# Access Compliance Report

## Public Rights-of-Way

Intersection ID: 27040	Main Street: PIPER_GLEN_DR	Cross Street: REA_RD	Location: SW
ADA ID: 44F1E026CE1C	Ramp Type: Directional1	Initial Pass/Fail: Fail	Overall Compliance: No
Codes/Mitigation Info/Possible Solution		Field Measurements/Component Compliance	
Severity Score: 13.75

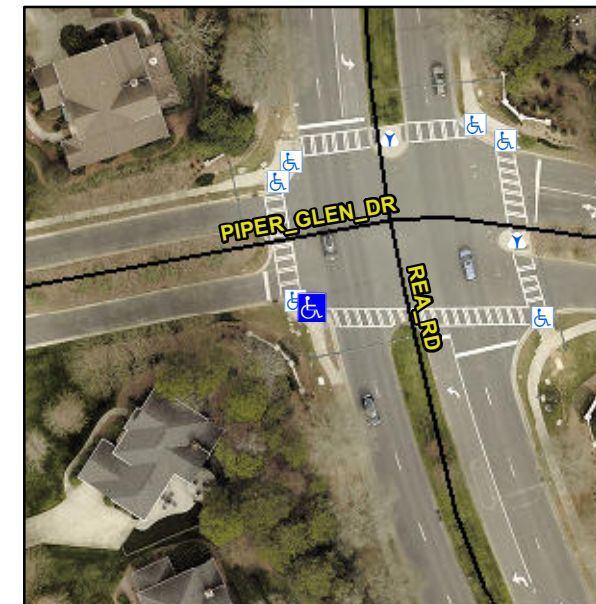
**R304.2.2, R304.5.3**

Compliance	Description	Data	Compliance	Description	Data
N/A	Ramp Length (in)	45.0	N/A	Grade Break?	N/A
Yes	Ramp Width (in)	72.0	N/A	Grade Break Slope (%)	0.0
No	Ramp Slope (%)	8.9	N/A	Grade Break XSlope (%)	0.0
No	Ramp XSlope (%)	3.0			
N/A	Flare Type LT	N/A	N/A	Flare Type RT	N/A
N/A	Flare Slope LT (%)	N/A	N/A	Flare Slope RT (%)	0.0
N/A	Flare Traversable LT?	N/A	N/A	Flare Traversable RT?	N/A
N/A	Landing Length (in)	0.0	N/A	DWS Provided?	N/A
N/A	Landing Width (in)	0.0	N/A	DWS Contrast?	N/A
N/A	Landing Slope (%)	0.0	N/A	DWS Length (in)	N/A
N/A	Landing X Slope (%)	0.0	N/A	DWS Full Width?	N/A
N/A	Landing Curb? (Y/N)	N/A	N/A	DWS Offset LT (in)	N/A
N/A	Shared Landing?	N/A	N/A	DWS Offset RT (in)	N/A
N/A	Gutter Ponding?	0.0	N/A	Gutter Slope (%)	N/A
N/A	Gutter Lip Ht (in)	0.0	N/A	Gutter X Slope (%)	N/A
N/A	Painted X Walk1?	Yes		Road Slope (%)	0.5
	X Walk 1 Direction	To NE		Road X Slope (%)	1.7
	X Walk 1 Width (in)	124.0		Clear Space?	N/A

X Walk 1 Slope (%)	0.5	N/A	Clear Space to XWalk (in)	N/A
	X Walk 1 X Slope (%)	1.7	N/A	Storm Grate/Utility Hazard?	N/A
N/A	Ramp inside XWalk1?	Yes		Storm Grate/Utility Type	
N/A	Any Obstructions?	N/A			N/A
	Obstruction Type		Yes	Surface Condition? (G/P)	Good
			N/A	Curb Slope (%)	6.0

**Remove & Replace Entire Ramp.**
